**DATE:** February 23, 2015  
**TO:** Plan Commission  
**FROM:** Matt Tucker, Zoning Administrator   
**SUBJECT:** Request for PD Alteration, 520-524 E. Johnson Street

The applicant requests to allow alterations to this particular Planned Development (PD) district, as a remedy to noncompliance issues relative to the as-built condition of the property. The applicant has requested administrative approval of this PD alteration, which has been denied by the DPCED Director. The applicant has chosen to request Plan Commission approval for the alteration.

# Bike parking approval next to 520 E. Johnson

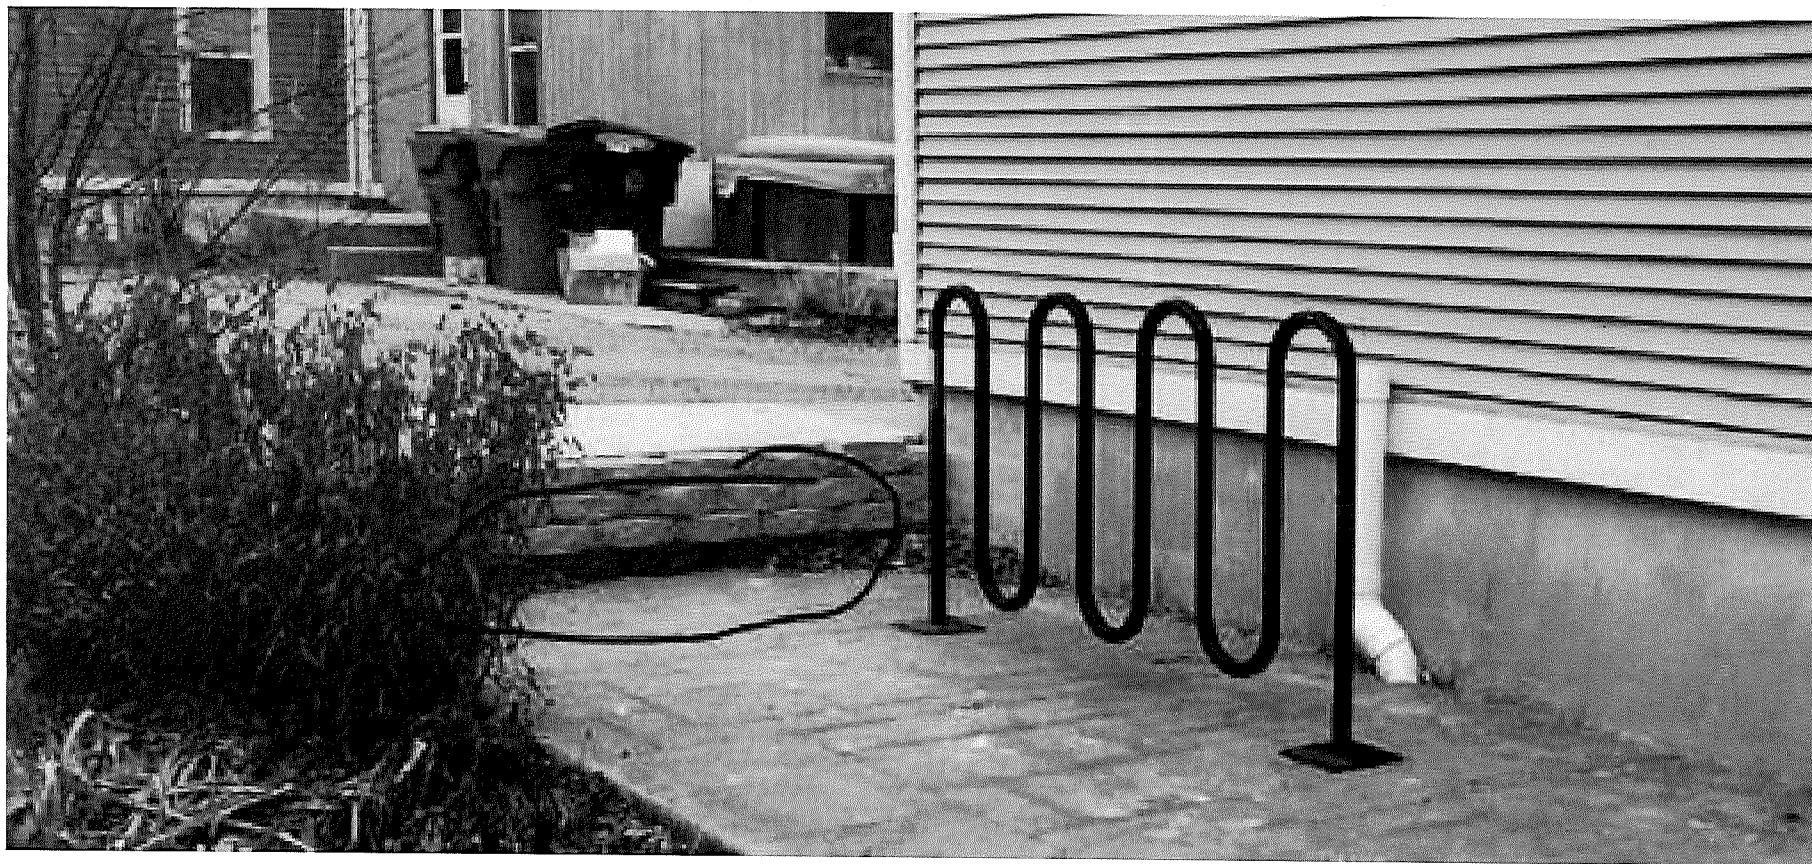
The bike parking access issue could be fixed if one added a step/steps in the retaining wall, so a person need not climb such a rise with a bike to get to the path leading to Blair Street.

Inadequate depth for parking and access, need 11', provide about 6'-7'

We also need a detail of the rack, to be sure it meets code and a re-orientation of the rack/bike parking stall. This configuration does not appear to hold bicycles correctly in their spaces, and affords little or no access around parked bikes in the rack. Rotating a rack and/or having a different rack design would accommodate the required bike parking

- Re-orient bike parking in this area to a compliant configuration that maintains the required access.
- Install a course of block at the front of the retaining wall to create a “step” that one may use to carry their bicycle between the driveway and the bike parking area.
- Provide a detail of the bike rack, showing the rack in compliance with Zoning Ordinance requirements.

# Approved plans for window well installation

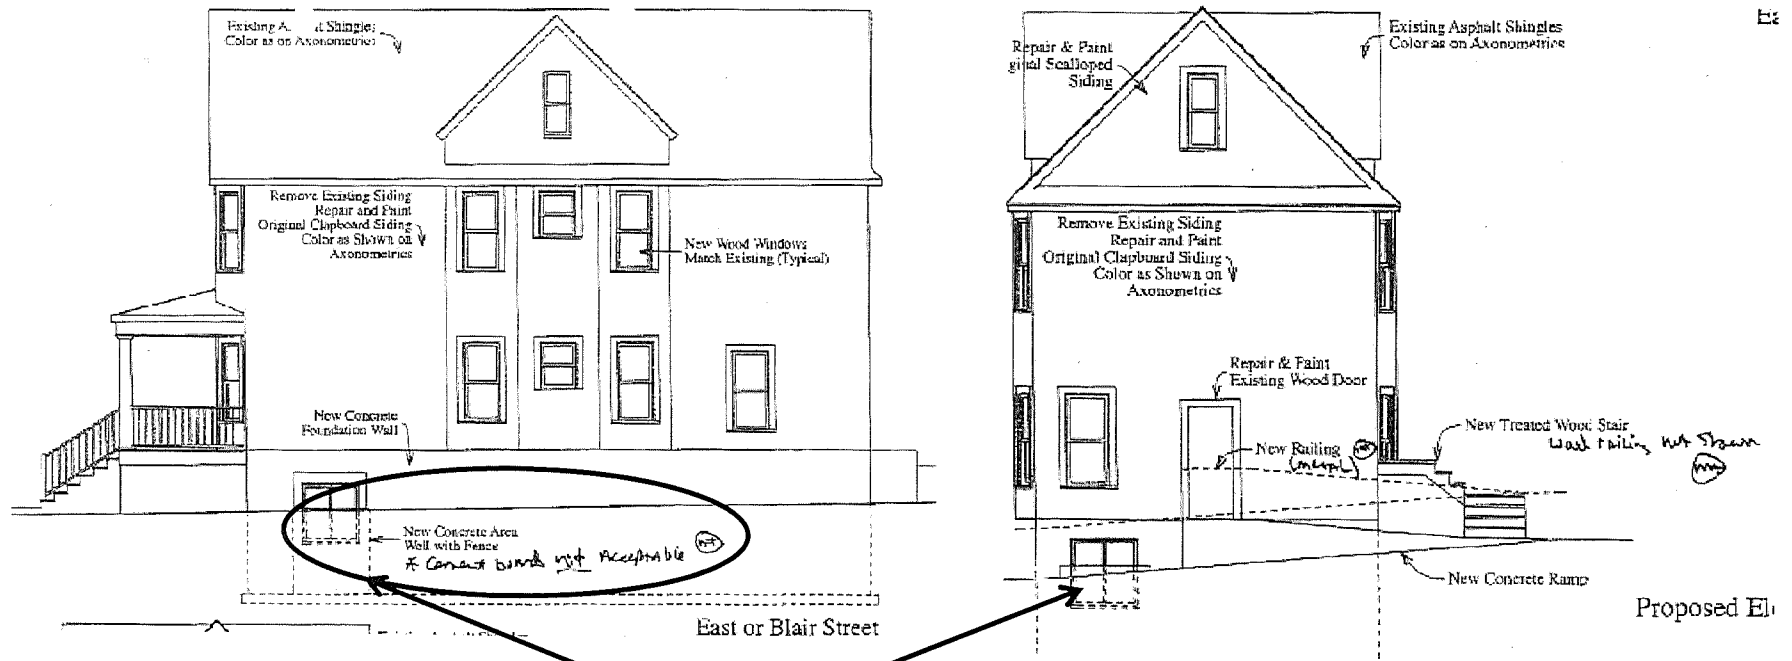
Unacceptable window wells installed here

- Reconstruct the window wells of masonry/concrete or another acceptable durable material.

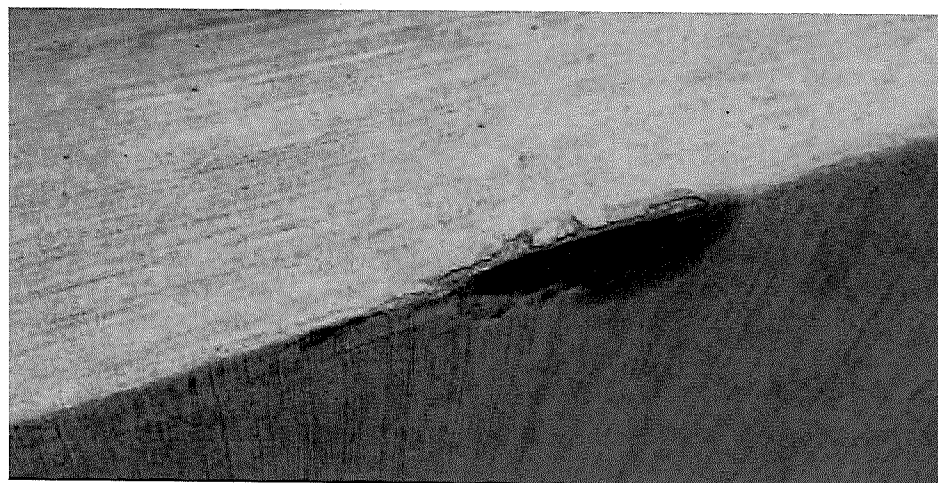
Here is the window well at the rear (driveway):

Here is a close-up of some existing damage, appear to be oxidizing/rusting and showing early sign of failure:

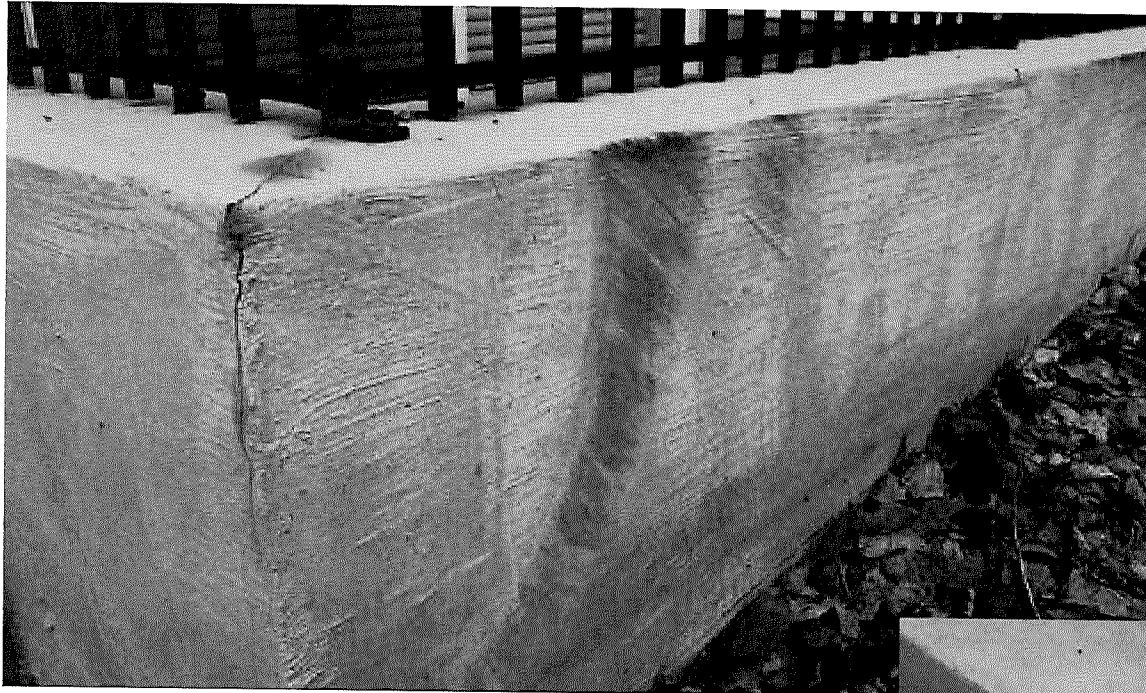
Here is the well by the sidewalk of N. Blair St., it already has a few marks where something hit it.

Here is a close-up of a crack that has developed on top, runs from front-to-rear, dark spots show moisture penetrating the structure. This shows failure, which is why we did not allow these installed in this location, this way. Concrete or masonry would have been acceptable.
